### COMMENT RESPONSES/REVISIONS TO THE DRAFT IMPLEMENTATION PLAN FOR ABOVE-GRADE DECONTAMINATION AND DISMANTLEMENT OF THE MAINTENANCE/TANK FARM COMPLEX

# OPERABLE UNIT 3

## MAINTENANCE/TANK FARM COMPLEX IMPLEMENTATION PLAN

### COMMENT RESPONSE PACKAGE

FIGURE 4-1 Maintenance/Tank Farm Complex Remediation Schedule

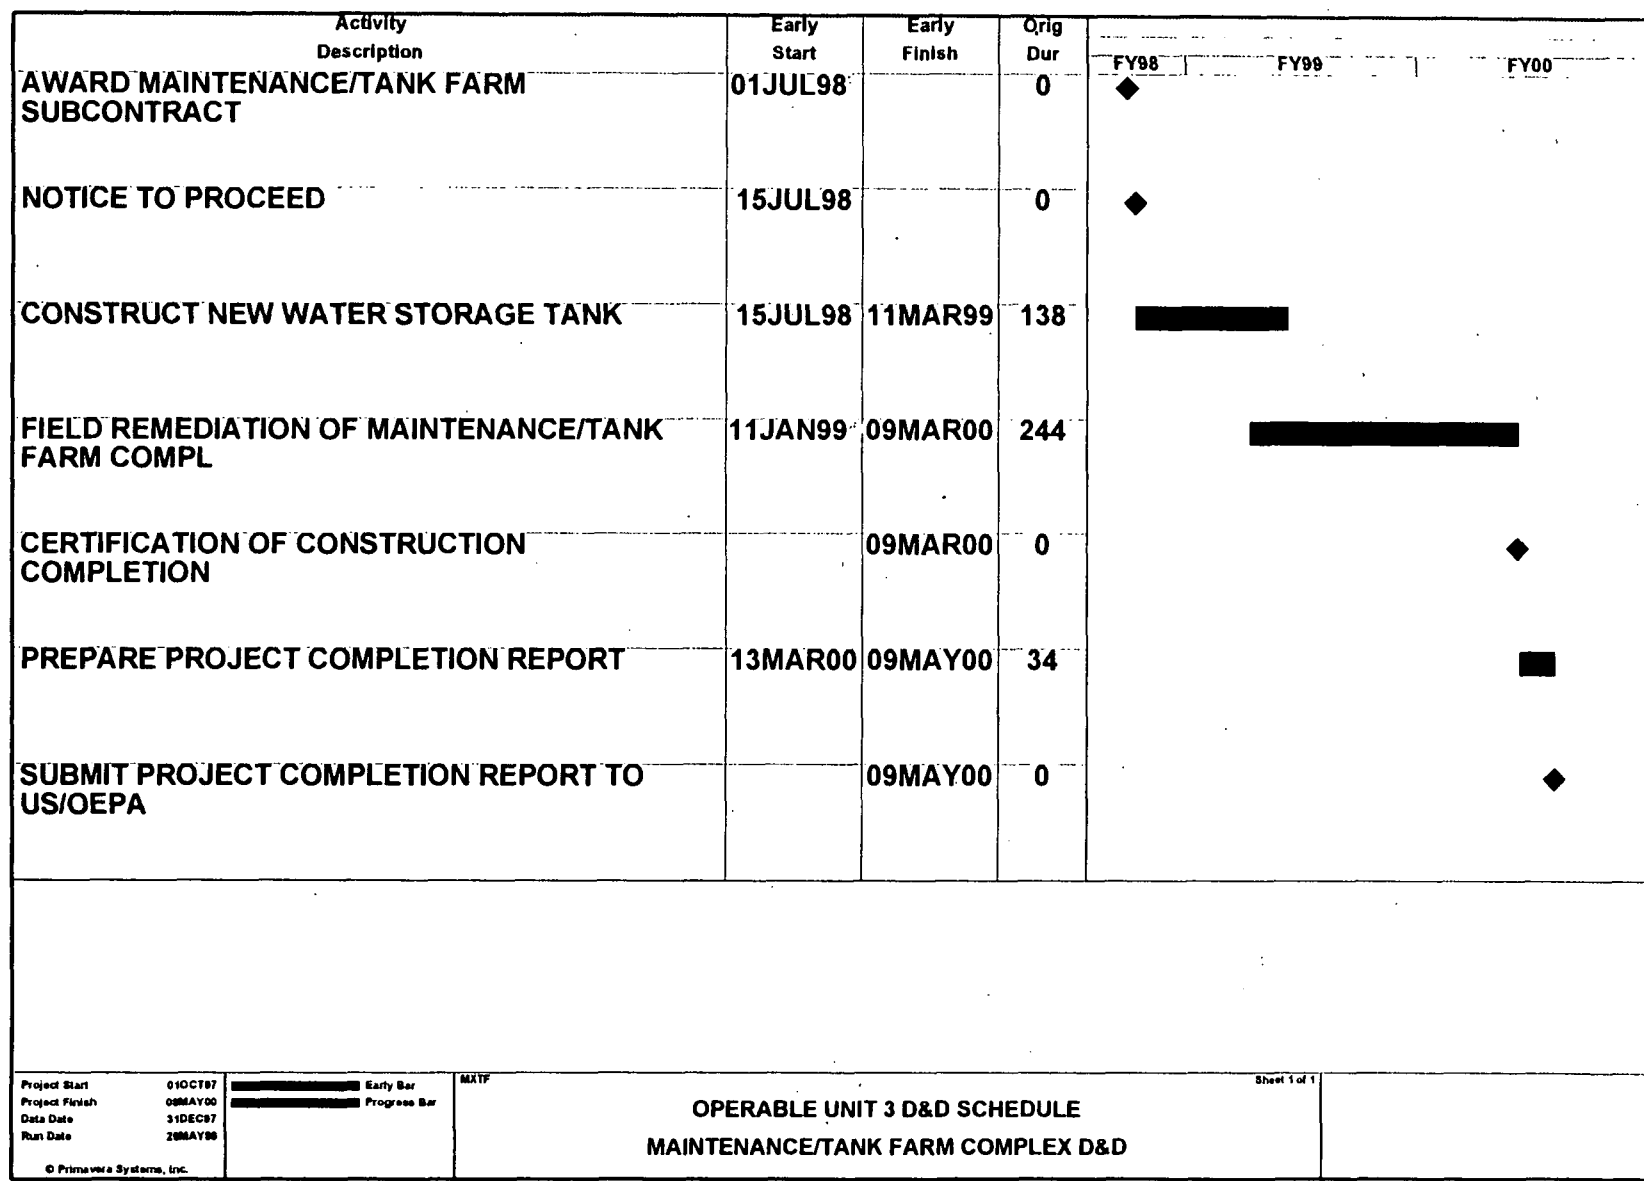
*Section 1.2 discusses the scope of work for the Maintenance/Tank Farm Complex project. The text states that Component 20H and Buildings 64 and 65 may be included in the scope of the project at a later date. The text also indicates that DOE will notify the regulatory agencies if Buildings 64 and 65 are added to the project scope. The text should be revised to add that the regulatory agencies will be notified if Component 20H is added to the project scope.*

Agree. It has recently been decided that the decontamination and dismantling of Building 64 (Thorium Warehouse) and Building 65 (Old Plant 5 Warehouse) will be included in the Maintenance/Tank Farm Complex D&D Project. Accordingly, the schedule has been revised to reflect the added scope.

The referenced text has been revised to reflect the above. For the revised implementation plan text in redline/strikeout format, please refer to pages 2 (lines 22 and 23, 26-29); 3 (lines 9-13, 15-25); 9 (lines 17-20); and 56 (Figure 4-1) in Section 3.0 of this document.
